Browns Summit Creek Restoration Project Year 3 Monitoring Report

DMS Project ID No. 96313, DEQ Contract No. 5792

Subject: Response to Task 9 Draft Year 3 Monitoring Report Comments for Browns Summit
(DMS #96313) Cape Fear River Basin; CU 03030002; Guilford County, North
Carolina Contract No. 005792

Figure 2
Restoration Summary Map
Browns Summit Site
(DMS #96313)

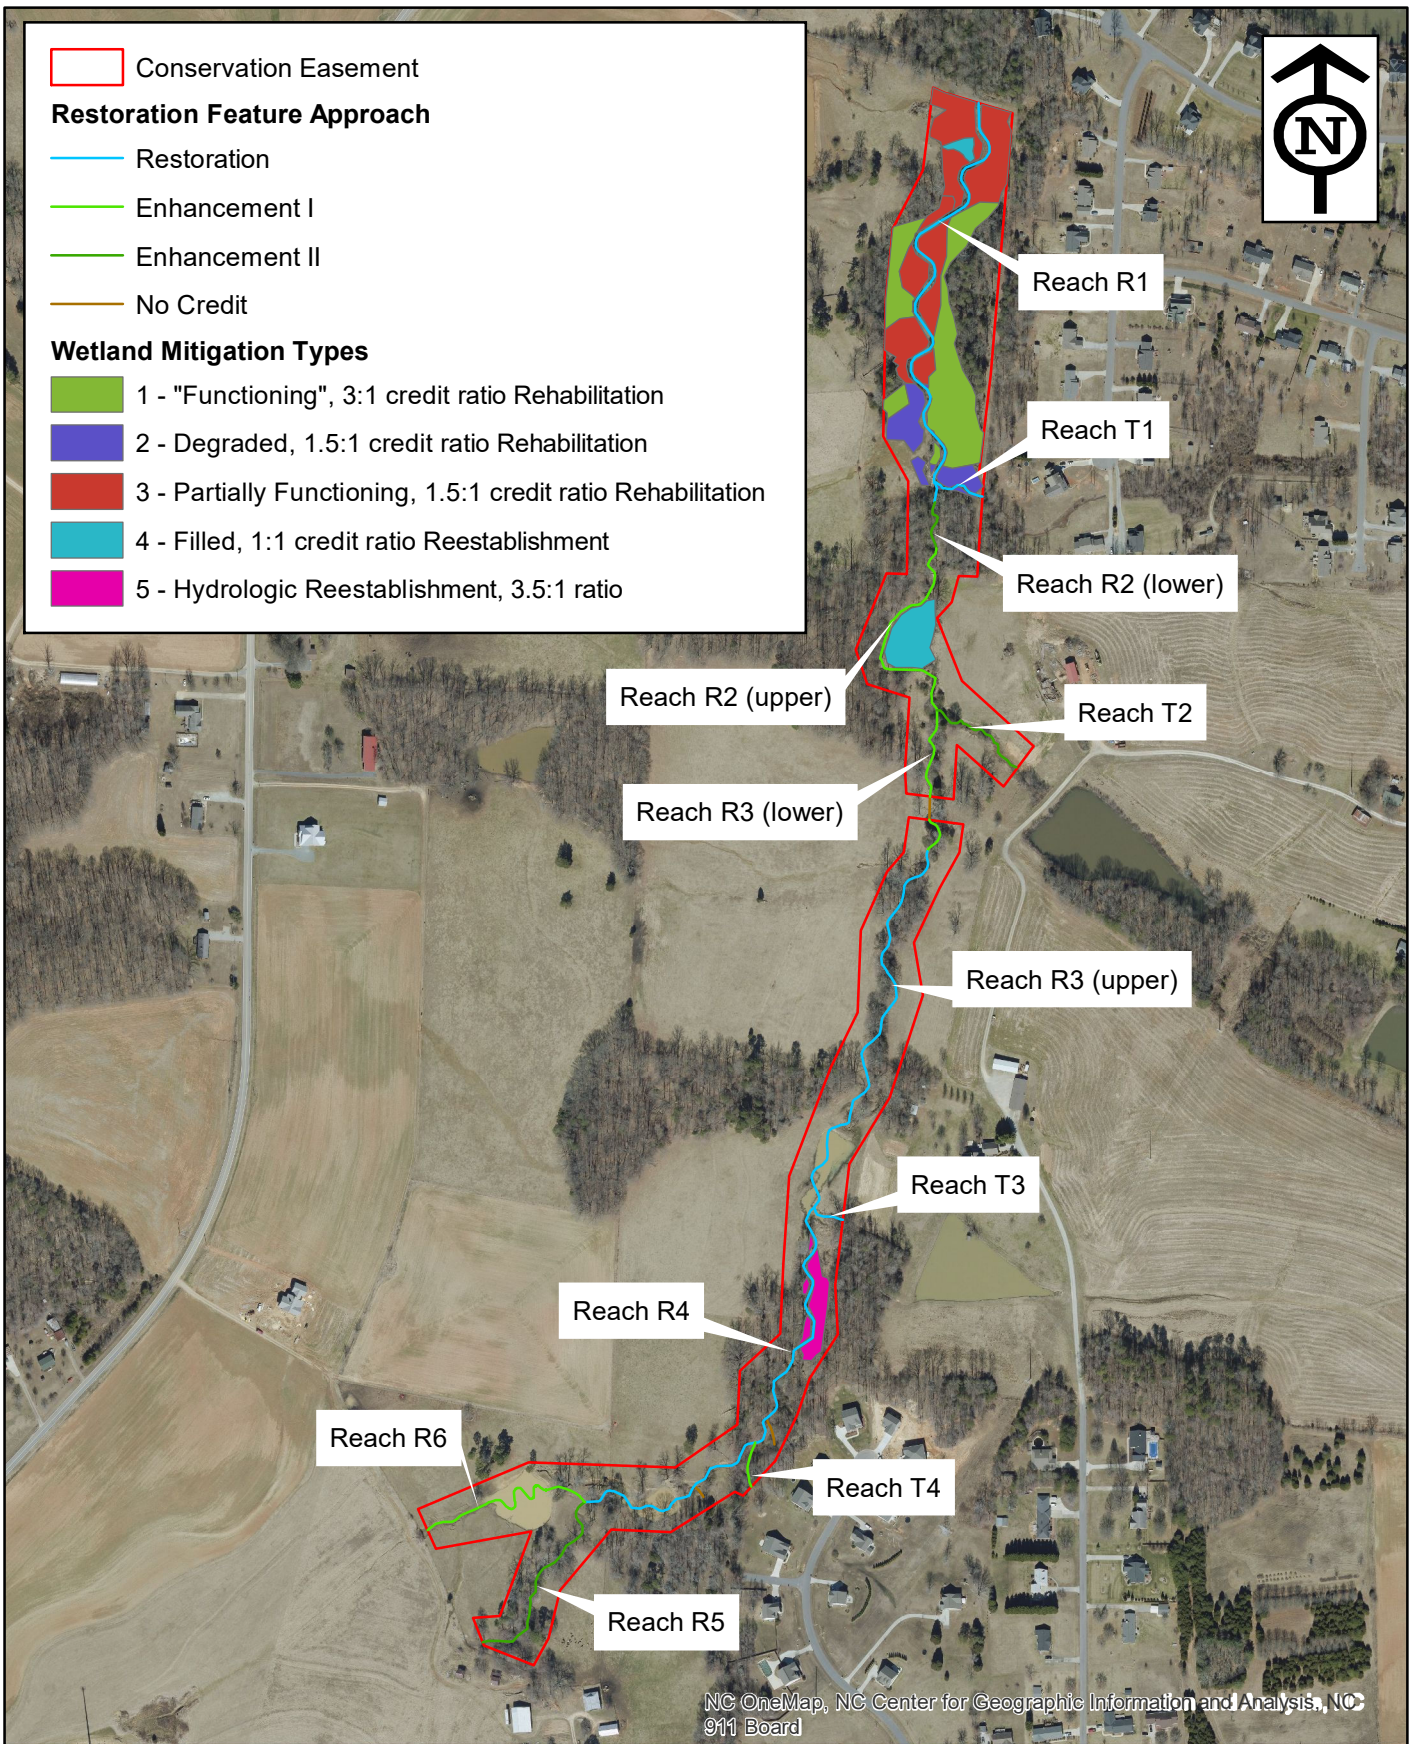
a. *Figure 2 – Please label “Wetland Mitigation Types” in the map legend as Re-establishment or Rehabilitation.*

Response: Figure 2 “Restoration Summary” has been revised to add wetland mitigation types to the map legend.

Figure 4.1
Current Conditions
Plan View
Browns Summit Site
(DMS #96313)

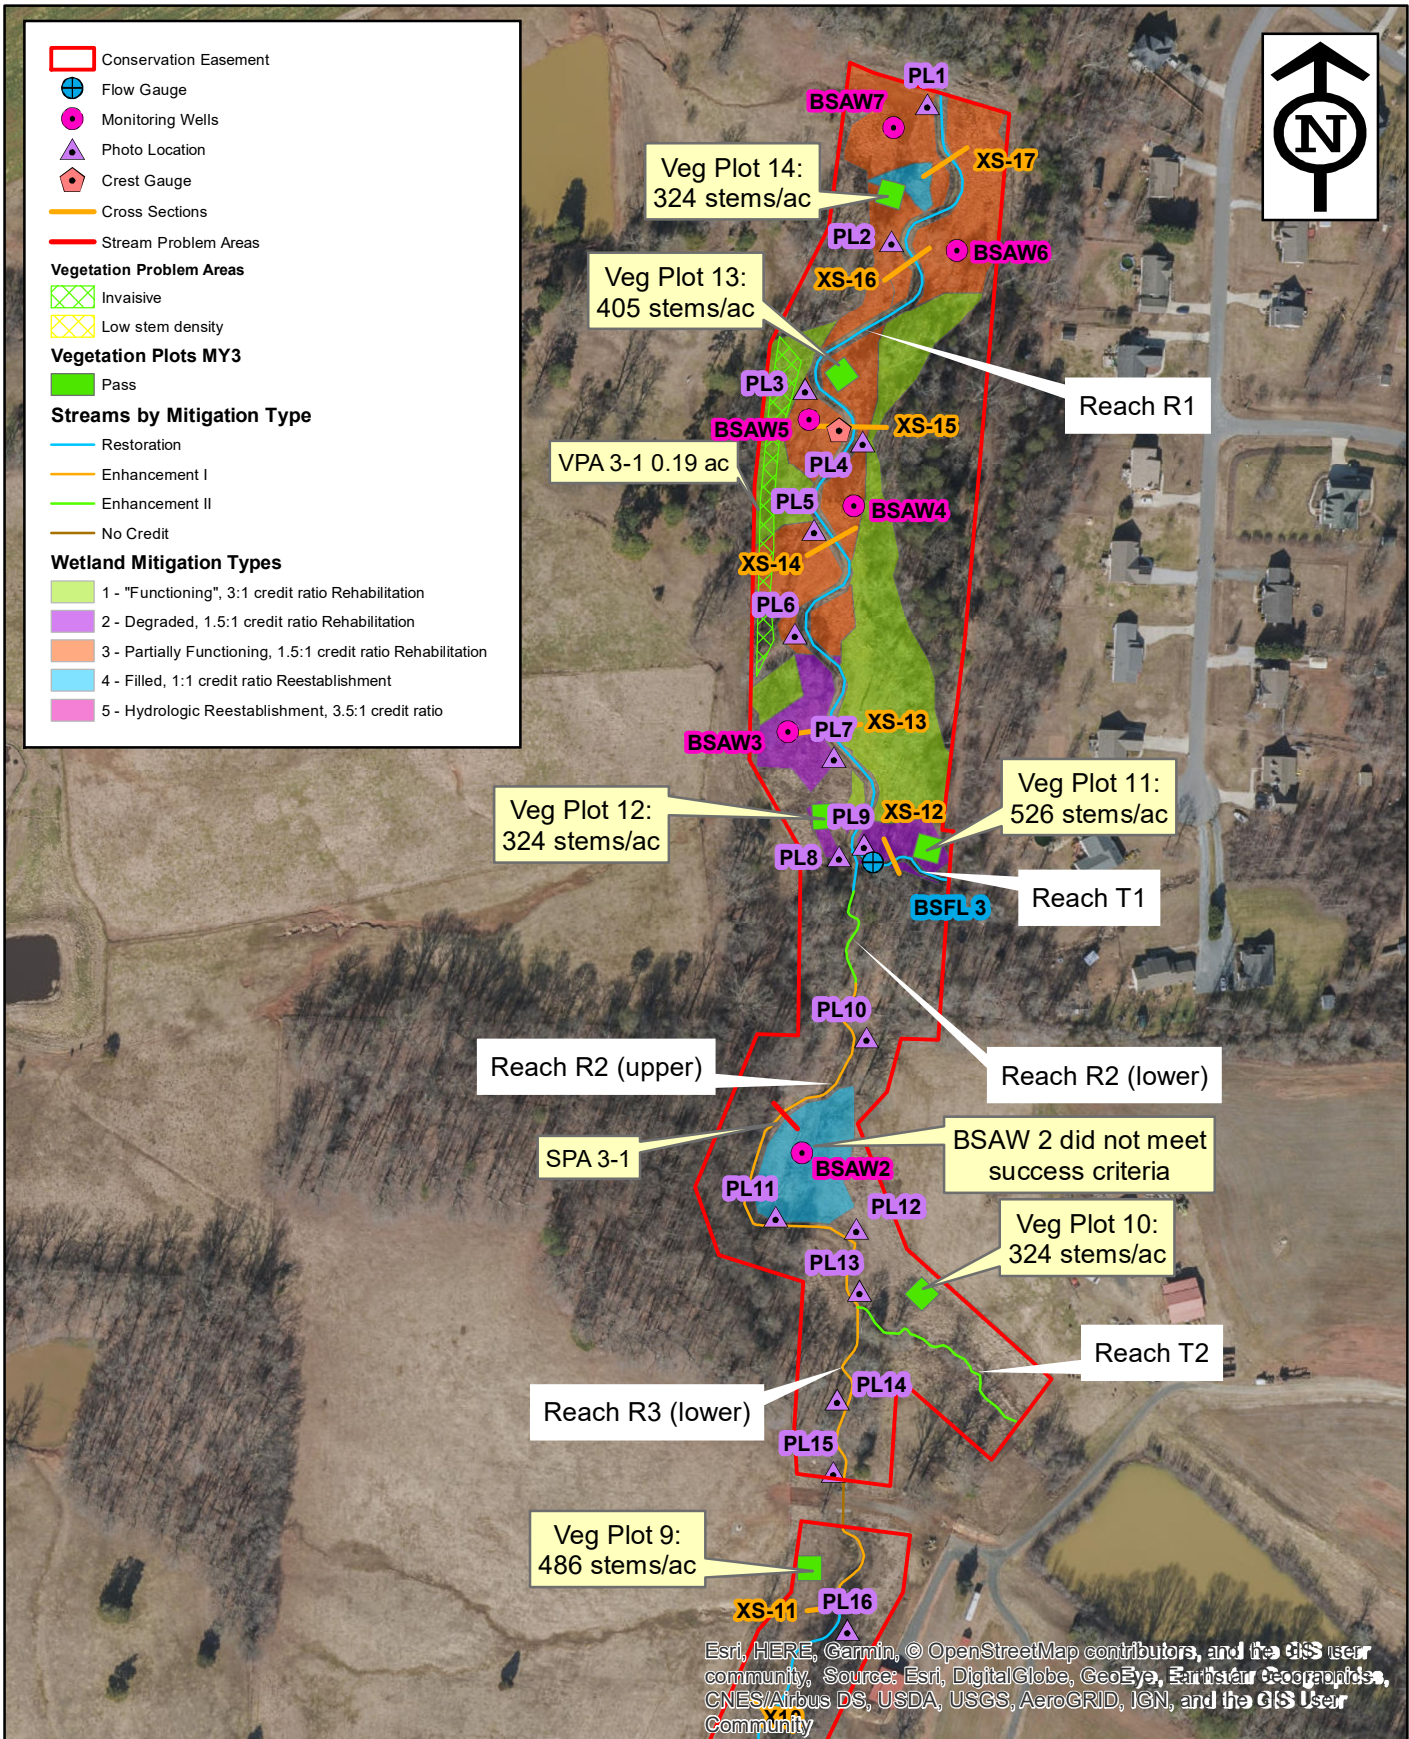
3. *Appendix B: a. Figures 4.1 & 4.2 – See comment 4a. Please add wetland mitigation type (re-establishment or rehabilitation) to the map legend. Also, please indicate graphically, or with a label on the map, that BSAW2 did not meet success criteria. It would also be helpful to differentiate the veg problem areas between invasive and low stem density areas with differing colors or labels.*

Response: Figures 4.1 and 4.2 have been revised to show wetland mitigation type, a note detailing that BSAW2 did not meet success criteria and veg problem areas broken down to distinguish the two different types.

Permanent Cross-section 1
(Year 3 Data - Collected October 2019)

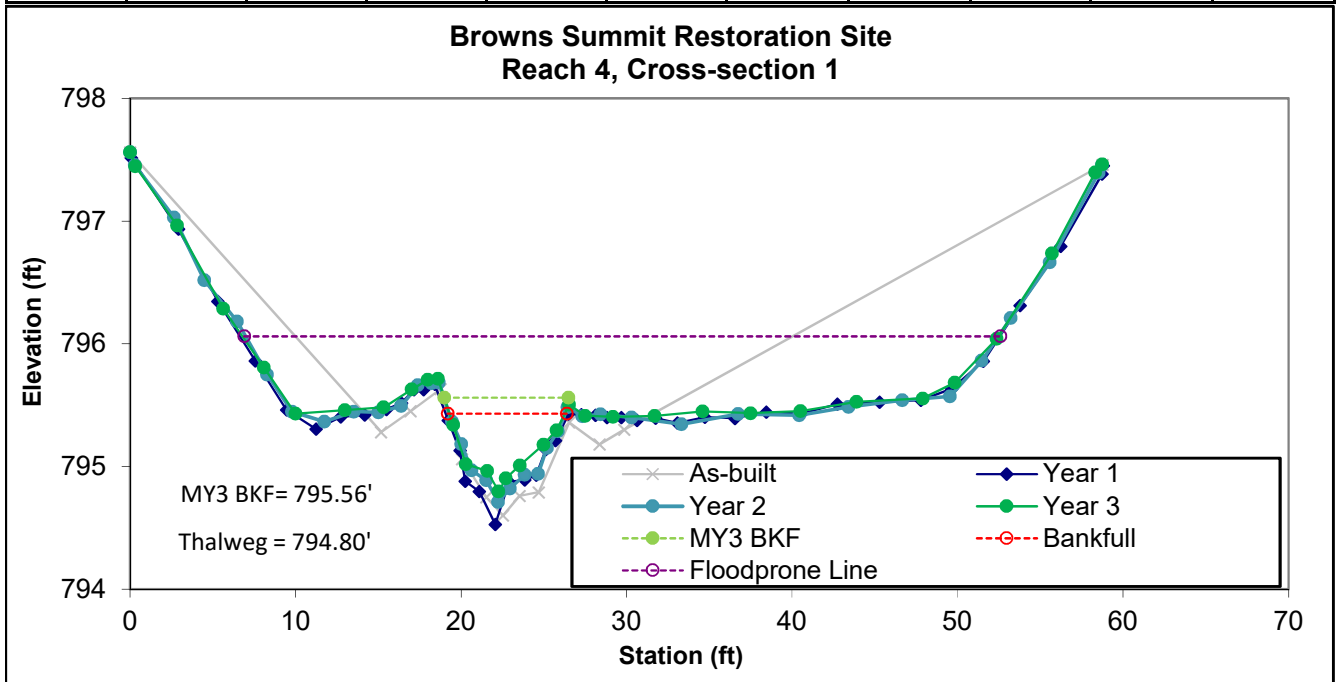
5. *Appendix D: a. Please verify BHRs. For example: On XS-1 it appears that there was some slight aggradation but the BHR is 1.1 in the report when a <1 BHR seems more appropriate. The bankfull line adjusted vertically based on MY1 cross sectional area (green line) being above the actual identified MY3 low top of bank (red line) would typically imply aggradation (see x-section 4). Also, BHRs of below one (1) can be reported as <1.*

Response: Figure 5 has been revised with updated BHR numbers and bankfull lines per DMS request. The numerical data has been maintained to simplify formulas utilized to create Table 11a and 11b (e.g. “<1” does not allow us to run formulas to pick up min, mean, med, max and standard deviation).
